**Before Independent Hearing Commissioners  
In Ngāruawāhia**

In the matter of of a submission by Ambury Properties Limited in respect of the proposed Waikato District Plan pursuant to Clause 6 of Schedule 1 of the Act seeking the rezoning of land at Ohinewai

**Statement of evidence of Robert Swears for Waka Kotahi – Transportation  
Engineering**

13 August 2020

Figure 1: Location of Intersections and Accesses Described in This Statement (image source: Inder, EIC, Figure 11)

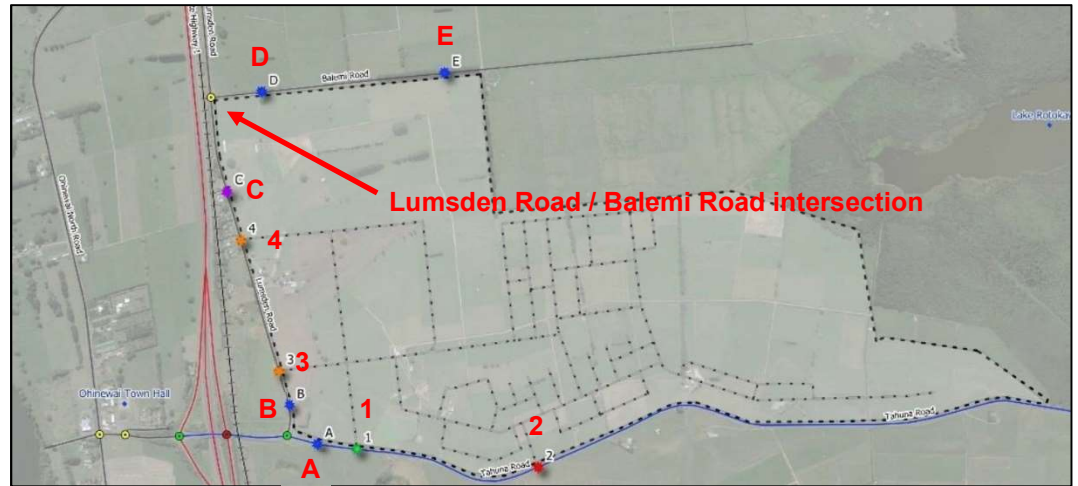
6.3 The locations of the accesses and intersections (listed above) along with the boundaries of the Site and the Lumsden Road / Balemi Road intersection are illustrated in Figure 1 below.

- 6.31 With regard to Intersection 1, the question that needs to be answered is how right turn movements will be accommodated. The Tahuna / Lumsden roundabout is relatively close (approximately 190 m) to Intersection 1 and the continuous central median between the intersection and the roundabout is likely to discourage many right turn in movements at Intersection 1. However, Intersection 2 is approximately 600 m to the east (and out of sight), therefore, I consider it unlikely road users would travel that far to facilitate the equivalent of a right turn out movement at Intersection 1.

- 6.33 The central island diameter of the Intersection 2 roundabout on Tahuna Road is illustrated as being 20 m (Inder, EIC, Figure 13), and an 80 km/h speed limit is proposed (Inder, EIC, Figure 20). If we assume that the design speed is the same as the speed limit<sup>5</sup>, Austroads<sup>6</sup> indicates that the minimum radius for the central island of a single lane circular roundabout should be 14 m (that is, 28 m diameter) and the desirable radius should be 22 m (that is, 44 m diameter). The Applicant is proposing a 20 m diameter, which is less than the minimum diameter described by Austroads. In my opinion, the Applicant should demonstrate at this stage that an appropriately designed roundabout can be provided and I recommend that provisions are included in the District Plan to require such a roundabout to be constructed.

10. Unacceptable road user movements associated with Intersection 1.	Eliminate Intersection 1 or replace with a roundabout.
11. Intersection 2 roundabout too small.	Design for adequate diameter. Repositioning of roundabout may be required or property purchase to accommodate full-size roundabout.

Figure 2: Existing Intersections in Vicinity of the Site (image source: Inder EIC, Figure 11)

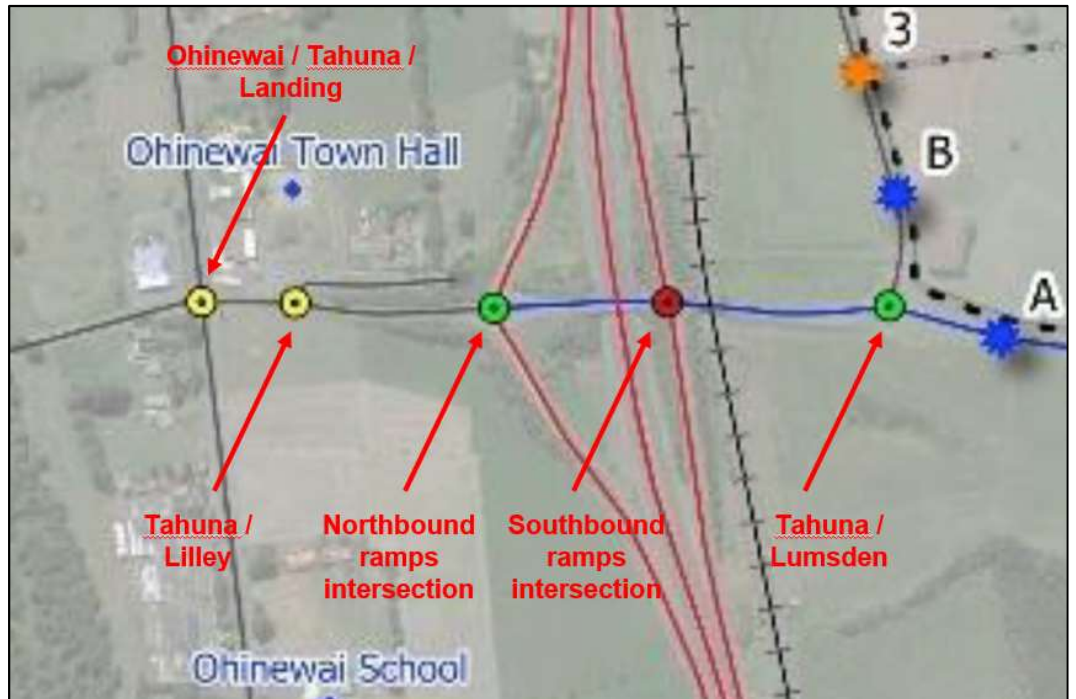
6.5 The location of the existing intersections listed above are illustrated in Figure 2 below.

**Figure 3: Map showing 30 km radius about the Tahuna / Lumsden intersection (image source: Data SIO, NOAA, US Navy, NGA, GEBCO, Google, Image Landsat / Copernicus, accessed on 29 July 2020)**

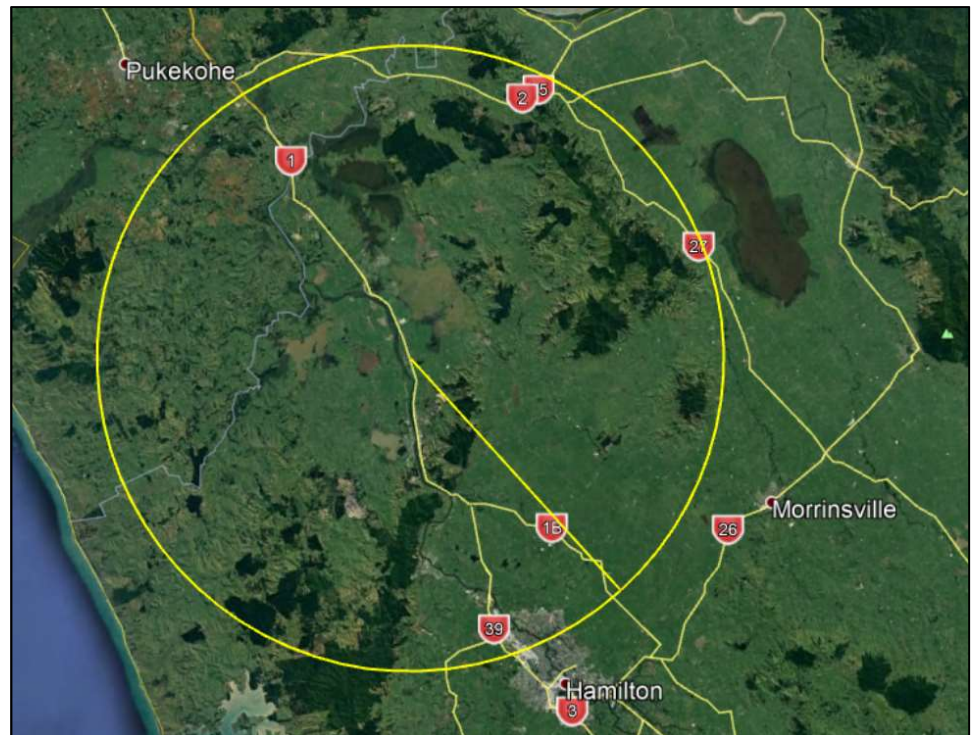
- 6.50 Mr Inder refers (EIC, paragraph 6.6(b)) to “[...] communities located within a 30km [sic]<sup>17</sup> radius from the Site, e.g. Pokeno, Pukekohe, South Hamilton [...]”. However, as illustrated in Figure 3 below, it is only the very northern suburbs of Hamilton that are within a 30 km radius of the Site, while Pukekohe is outside that 30 km radius. In addition, it is important to note that road transport journeys ordinarily follow alignments that are not in a straight line, therefore, a 30 km radius from the Site is not necessarily a 30 km journey from the Site<sup>18</sup>.

Figure 6: Southbound vehicle (red circle) on Willoughby Street (Hamilton) turning right into property despite presence of solid median and “no right turn” sign (blue circle)

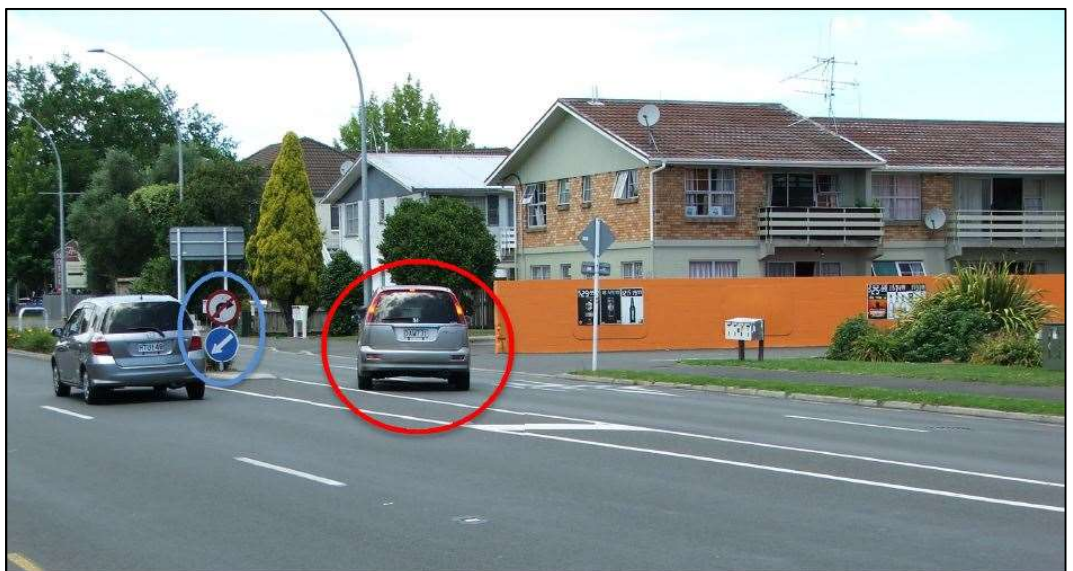
- 4 Figure 6 below illustrates a southbound driver turning right into the Thirsty Liquor site, on Willoughby Street in Hamilton, despite the presence of a median island to discourage the movement and a “no right turn” sign to prohibit the movement.
